Cobra Motorcycle Mfg.

TSB0309 Cobra Frictional Drive (CFD) Version 2 (V2)

September 18, 2008

Figure 1

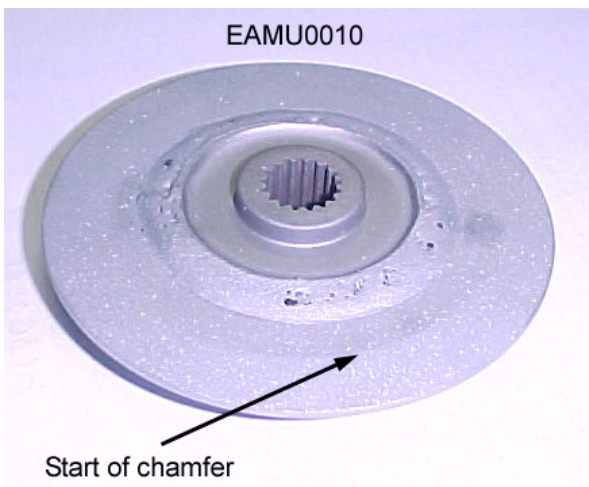
For 2009 the CFD “slipper” hub/pressure plate and centering washer have been improved. The old CFD hub/pressure plate (EAMU0008) is being discontinued and is being replaced with part number EAMU0010. The EAMU0010 must be used in conjunction with a new centering washer (ECMU0169) which replaces the previous ECMU0160.

This new CFD hub/pressure plate (EAMU0010) is the recommended service replacement part for engines with EAMU0008, or even the older two components setup (hub and pressure plate are separate). When making this replacement a new style centering washer (ECMU0169) must be used along with it.

The new style CFD hub/pressure plate can be identified by the presence of a slight chamfer on the back surface (figure 1). The new style centering washer can be identified by the presence of a large radius on the outer edge (figure 2).
